LIC-07-0084
October 5, 2007

SUBJECT: Fort Calhoun Station, Unit No. 1, License Amendment Request, "Change to Diesel Generator Surveillance Testing"

**Omaha Public Power District's
Evaluation of the Proposed Change**

“Change to Diesel Generator Surveillance Testing”

EXISTING FCS DG STARTS

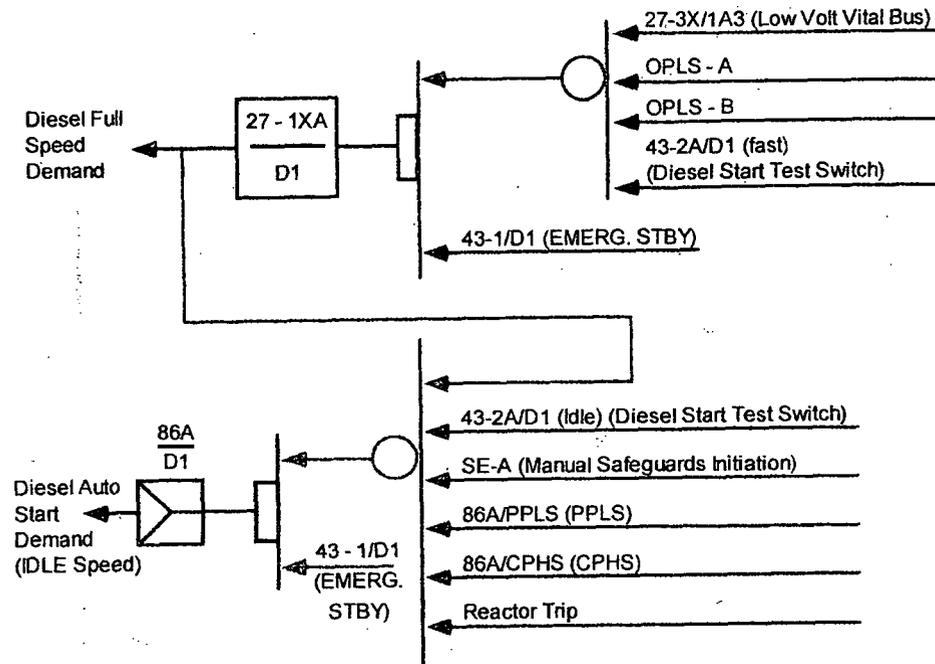
This LAR addresses the previous NRC concerns of removing the ESF start signals. The ESF signals (PPLS and CPHS) as proposed will provide DG full speed starting. DG full speed starting will also occur on any safety bus undervoltage condition. Sketches of the existing FCS DG starts and the proposed FCS DG starts are provided in Attachment 3 for information purposes.

Modification EC 33661 will remove the anticipatory (idle speed) DG start signal from the RPS on a reactor trip, such that the DGs start and accelerate to full speed on an undervoltage condition or an ESF signal. Removal of the RPS anticipatory (idle speed) DG start signal does not change the function of the DGs as they still provide emergency power to their respective buses when required.

This LAR responds to those previous NRC concerns of removing the ESF start signals. The ESF signals (PPLS and CPHS) as proposed will provide DG full speed starting. DG full speed starting will also occur on any safety bus undervoltage condition. Sketches of the existing FCS and proposed FCS DG starts are provided in Attachment 3 for information purposes.

- A. Set the governor droop setting to zero which will eliminate the use of the governor travel limit switch.
- B. Disable the idle-to-full speed acceleration signal to provide improved speed control of the engine.
- C. Disable the RPS automatic anticipatory start signal to eliminate no-load diesel operation.
